## Portsmouth Cycle Forum response to City Centre Road Scheme

### 17/02066/CS3

Portsmouth Cycle Forum would like to **OBJECT** to this road scheme in its present form.

### Western side

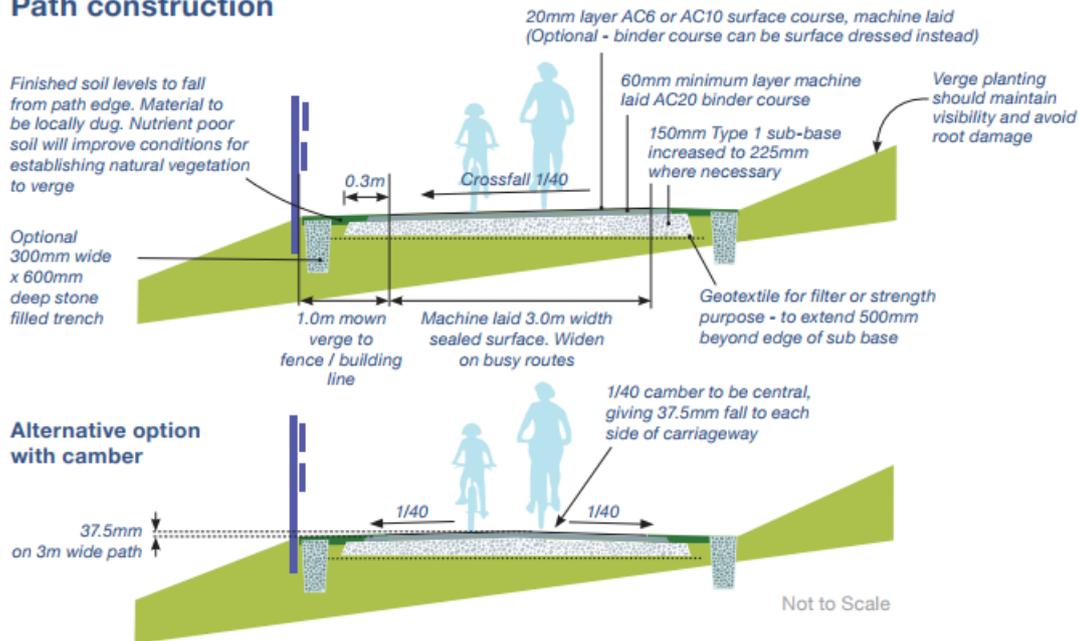
This looks well designed. The only addition would be to create raised tables at junction 10 and the junction to the south of the petrol station as a form of traffic calming.
